BUILDING CODE OF AUSTRALIA + ACCESS REPORT
PROPOSED MIXED USE BUILDING
141 WALDRON ROAD, CHESTER HILL NSW

Report Number & Revision:	MSA1067AA-REV02
Prepared For:	WALDRON ROAD PROJECTS c/- CMT ARCHITECTS
Date of Issue:	29.03.2017

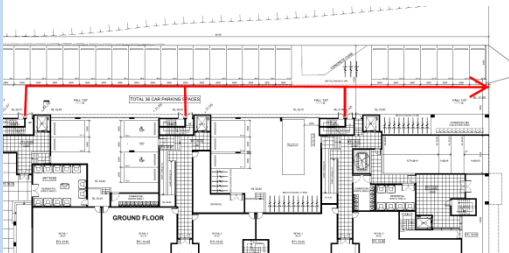
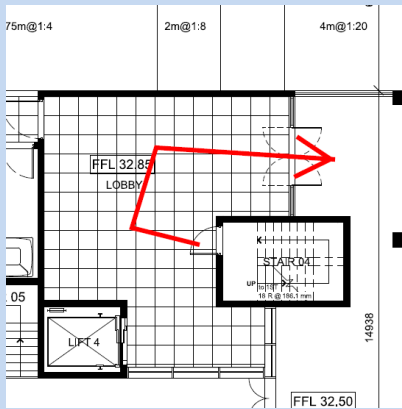
D1.3 When Fire Isolated exits are required	X			Fire isolated exits are generally provided as required. It is assumed that the southern wall of Stair 5 at ground floor level can achieve FRL of not less than 90/90/90:  <i>Note comments in Clause D1.7 in relation to the discharge of fire stairs.</i>
D1.4 Exit Travel Distances		X		Basement & retail areas – there must be no points on the floor more than 20m from an exit, or a 'point of choice' to alternative exits. (and the maximum distance to the nearest exit must not exceed 40m) Class 2 – unit entrance doors- must be no more than 6m from an exit or a 'point of choice' to alternative exits Class 2 – Other areas (common areas) – there must be no points on the floor more than 20m from an exit, or a 'point of choice' to alternative exits. Non-compliance to be addressed The following issues are noted <ul style="list-style-type: none"> Basement 2 – there are points on the

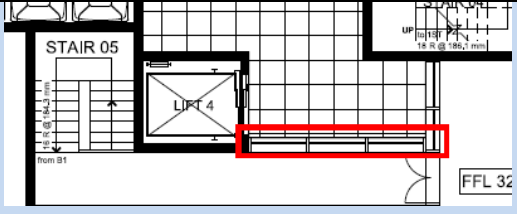
D1.6 Dimensions of Exits and paths of Travel to Exits			X	<p>Exits and paths of travel to exits are required to be unobstructed for a width of no less than 1000mm wide and a height of no less than 2000mm – see D2.17 also.</p> <p><i>Note comments in D1.4 above in relation to egress layout in basement levels.</i></p> <p>The exit doors are required to be not less than 750mm clear. (note that doors in an accessible pathway must be not less than 850mm clear - refer to Part D3 of the report for further details)</p> <p><i>Details to be provided at CC stage.</i></p>
D1.7 Travel via Fire Isolated Stairs		X		<p>The fire isolated exits must discharge directly to the road/street, or to 'open space' or to a covered area permitted by BCA D1.7 (b) (ii) or (iii).</p> <p>Where the path of travel from a fire exit necessitates passing within 6m of the external wall of the building measured at right angles to the path of travel) – then that part of the wall must achieve a min FRL of 60/60/60 and any openings in that wall must be protected internally in accordance with BCA C3.4.</p> <p>Non-compliances to be addressed:</p> <ul style="list-style-type: none"> The exits discharging on the southern side of the building – egress west along the driveway to Campbell Hill Road. The path of travel from the exits (shown in red below) passes within 6m of the southern external wall.

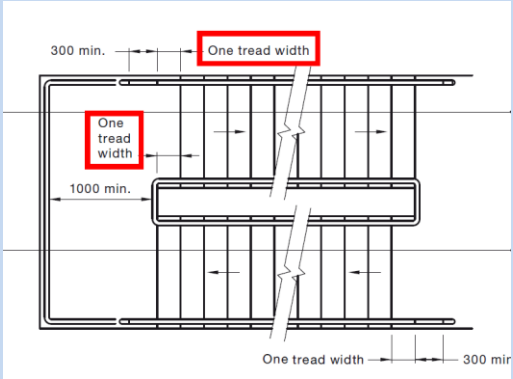
BCA DEEMED-TO-SATISFY PROVISION	Complies Does Not Comply	NA or Informational Compliance Required	COMMENTS/RECOMMENDATION
			 <ul style="list-style-type: none"> Stair 4 discharges into the ground floor lobby – which is not permitted under BCA D1.7. 
D1.8 External Stairways or ramps in lieu of Fire Isolated Stairs		X	There are no external stairs being used in lieu of fire isolated exits.
D1.9 Travel by non-fire-isolated stairs		X	All stairs are typically required to be fire isolated.
D1.10 Discharge from Exits Note NSW D1.10			X The path of travel between the exits and open space appear to be generally on-grade. Additional bollards are required to be provided to the final egress doors from the fire exits on the southern side of the building. <i>Details to be provided at CC stage.</i>
D1.11 Horizontal Exits		X	There are no horizontal exits relied upon for the purposes of this assessment
D1.12 Non-required stairways, ramps or escalators		X	There are no 'non-required' stairs or ramps

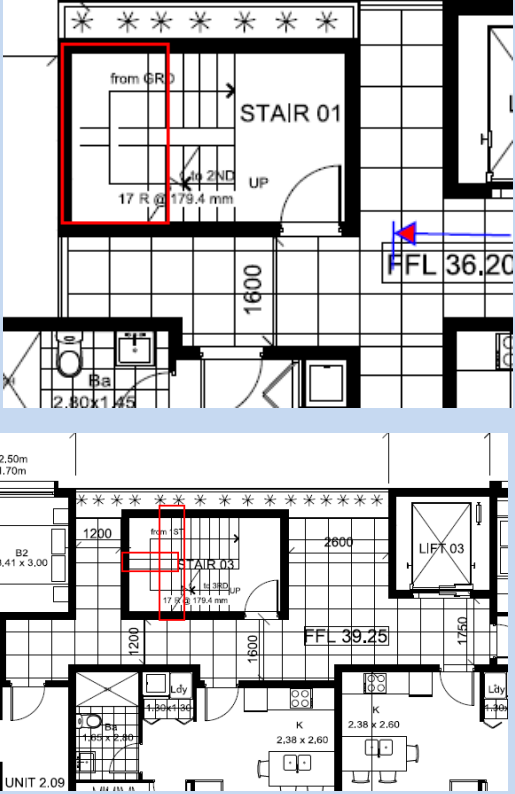
D2.5 Open Access ramps and balconies		X		There are no open access ramps or balconies required to be provided for smoke hazard management.
D2.6 Smoke Lobbies		X		Smoke lobbies are not required to be provided.
D2.7 Installations in Exits and Paths of Travel			X	Electrical distribution and telecommunications, boards etc. where located in a path of travel to an exit, must be enclosed in non-combustible construction, with openings suitably smoke sealed. <i>Details to be provided at CC stage.</i>
D2.8 Enclosure of Space Under Stairs and ramps		X		There are no such enclosures indicated on the plans.
D2.9 Width of Stairs		X		Informational clause only.
D2.10 Pedestrian Ramps		X		There are no ramps proposed.
D2.11 Fire-Isolated Passageways		X		The FRL of the fire isolated passageways must generally meet the FRL of the fire stair which it serves – however where the wall of the passageway adjoins a part of the building required to have a higher FRL (e.g. a wall between a fire passageway and a retail tenancy), the higher FRL should be provided. Non-compliances to be addressed: <ul style="list-style-type: none"> The southern wall of Stair 5 at ground floor level must achieve FRL of not less than 90/90/90:

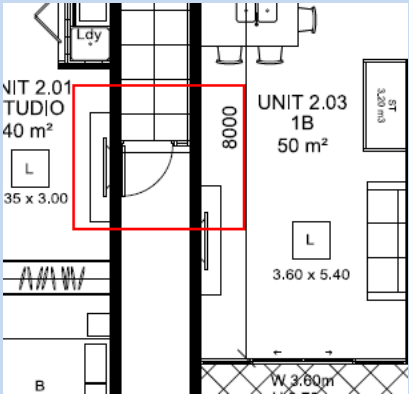
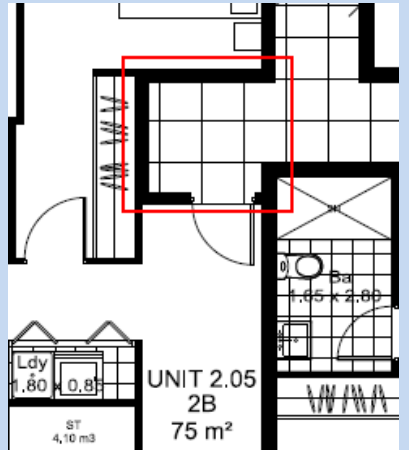
BCA DEEMED-TO-SATISFY PROVISION	Complies Does Not Comply	NA or Informational Compliance Required	COMMENTS/RECOMMENDATION
D2.17 Handrails		X	<p>A handrail is required to at least one side of every stairway or ramp (except for stairs/ramps serving a change in elevation of less than 1m)</p> <p>The handrail must be continuous between stair flight landings and have no obstructions that will tend to break a hand-hold (except for newel posts , ball type sanctions or the like)</p> <p><u>Note the additional handrail requirements in Part D3</u></p> <p>The height of the handrail must be not less than 865mm above the nosing line of the stairs or ramp surface.</p> <p>As the fire isolated exits serve areas required to be accessible – they must be provided with handrails – designed and constructed to comply with Clause 12 of AS1428.1-2009.</p> <p>This generally requires the staggering of risers/treads at landings to allow the handrail to maintain a continuous height throughout the flight (see extract below).</p> <p>Particular attention to be paid to quarter landings (these are not typically practical)</p> <p><i>Details to be provided at CC stage.</i></p>  <p>Non-compliance to be addressed</p> <ul style="list-style-type: none"> The handrails throughout all fire stairs must be provided with handrails – designed and constructed to comply with Clause 12 of AS1428.1-2009 (this requires modification to the current design).

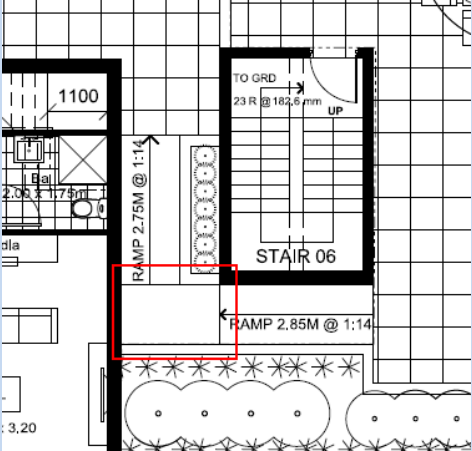
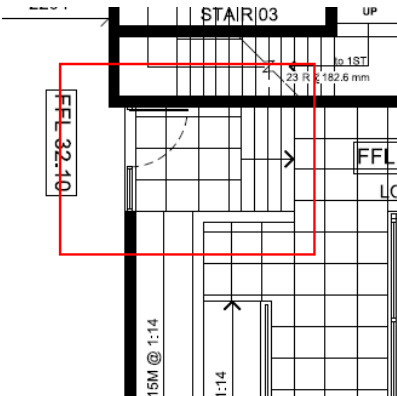
BCA DEEMED-TO-SATISFY PROVISION	Complies Does Not Comply	NA or Informational	Compliance Required	COMMENTS/RECOMMENDATION
				 <p>Details to be provided at CC stage.</p>
D2.18 Fixed Platforms, walkways and ladders			X	Informational clause only noting fixed platforms, walkways and ladders for access can be in accordance with AS1657 to service areas.
D2.19 Doorways & Doors Note NSW D2.19	X			Swinging or sliding doors have are proposed as required.
D2.20 Swinging Doors		X		<p>The final egress doors are required to swing in the direction of egress as required (or are sliding).</p> <p>The swing of doorways opening into the fire stair must not encroach more than 500mm into the required width of the exit (1m), or encroach by more than 100mm when fully open.</p> <p>Details to be provided at CC stage.</p> <p>Non-compliance to be addressed:</p> <ul style="list-style-type: none"> The door from Stair 5 at ground floor level swing against the direction of egress.

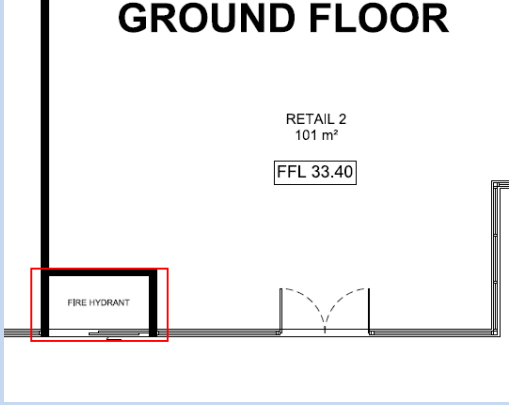
BCA DEEMED-TO-SATISFY PROVISION	Complies Does Not Comply	NA or Informational	Compliance Required	COMMENTS/RECOMMENDATION
				<ul style="list-style-type: none"> Access between the 'square' and the retail level (as shown below) must be provided by lift or ramp, where the square serves as a pedestrian entrance to the retail areas.  <p>Class 7a Parts – access must be provided to any level containing accessible carparking spaces.</p> <p>Access between the basement levels and the building is provided by way of passenger lifts – Generally complies/ramps.</p> <p><i>Full details must be submitted at CC stage</i></p>
D3.2 Access to Buildings		X		<p>An access way must be provided to the building from:</p> <ul style="list-style-type: none"> the main points of pedestrian entry at the allotment boundary from another accessible building connected by a pedestrian link any accessible carparking space on the allotment
